S.A.T.	263 MV
area	n°

Service Bulletin

Subject: Fusebox holder

Product: Brutale 1000 Serie Oro - RR - Rush

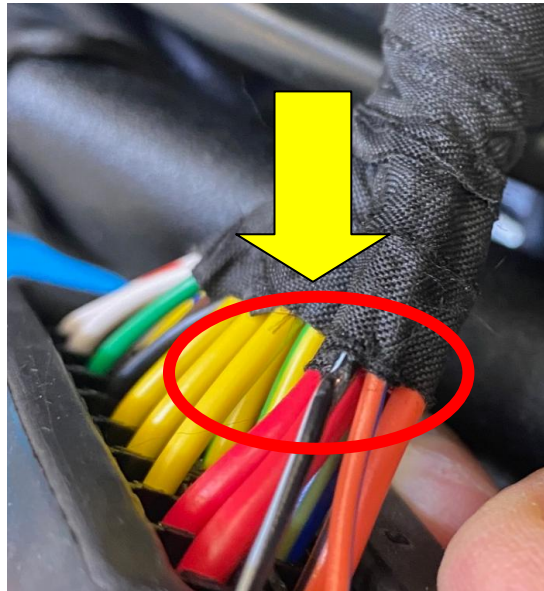
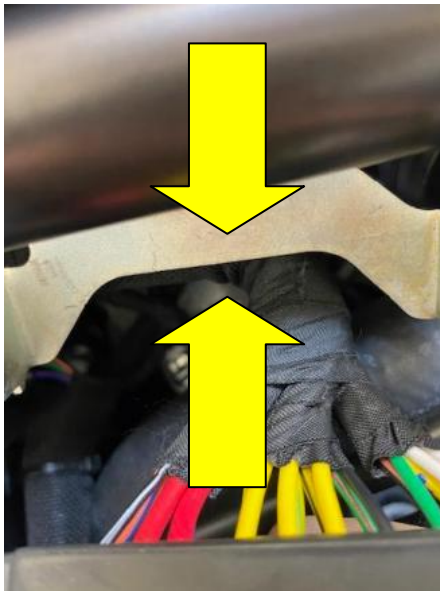
As a result of continuous monitoring of the quality of our product it has been found that for the Brutale 1000 Serie Oro - RR - Rush motorbike purchased by you, it is necessary to apply a rubber protection on the fuse-holder as an accidental contact with the wiring could damage the harness:

After removing the aluminium cover on the left side of the motorbike and removing the fuse box from its support, clean the surface indicated carefully and apply the rubber protection code **8D00B4458** (the protection is already supplied with adhesive):

Please place the fuse box back on its support, taking care to keep the wiring away from the edge of the support and reassemble the previously removed aluminium cover.

PROCEDURE FOR IDENTIFICATION OF NON-COMPLIANT PART:

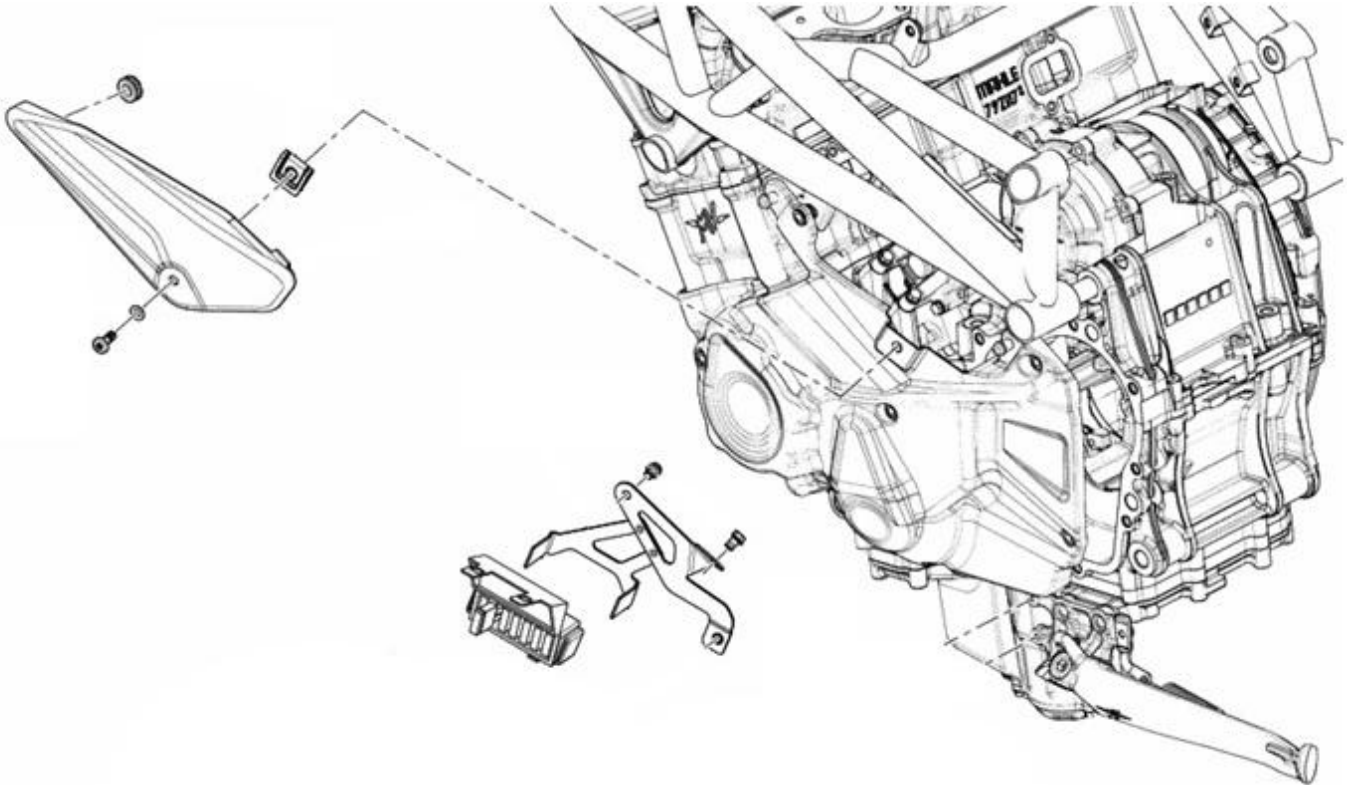
It will be possible to identify the motorcycles that needs to be updated by removing the aluminum cover on the left side of the bike, using a 4mm Allen key and acting on the quick release screw; Once the cover has been removed, remove the fuse box from its support and check the presence or absence of the rubber protection on the previously indicated area.
